TECHNICAL SERVICE BULLETIN

1988 TRUCK SIDE WINDOW SPACER

NO.	TSB-88-23-010
DATE	August, 1988
MODEL	1989 Truck

TSB Revision TSB-88-23-010

BODY – Side Window Glass 23-27

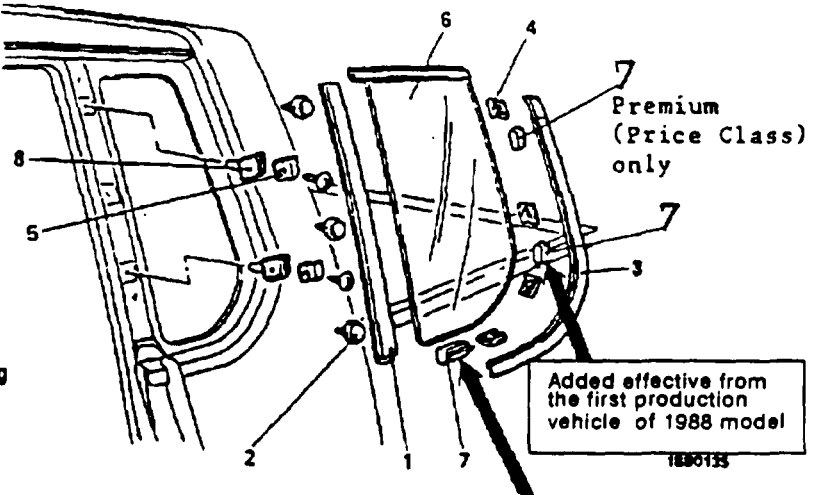
Page 23-27: The lower window spacer is not used, and a center spacer is added as shown in the illustration below.

7. INSTALLATION OF WINDOW SPACER

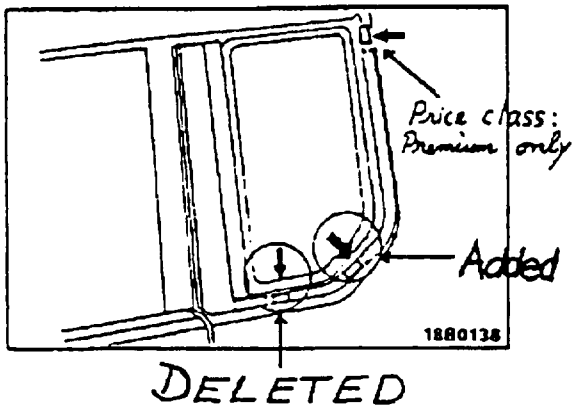
Page 23-28: Revise the illustration on this page as shown.

Align the window spacer with the edge of the windc
ing clip and install in the position shown in the diagr
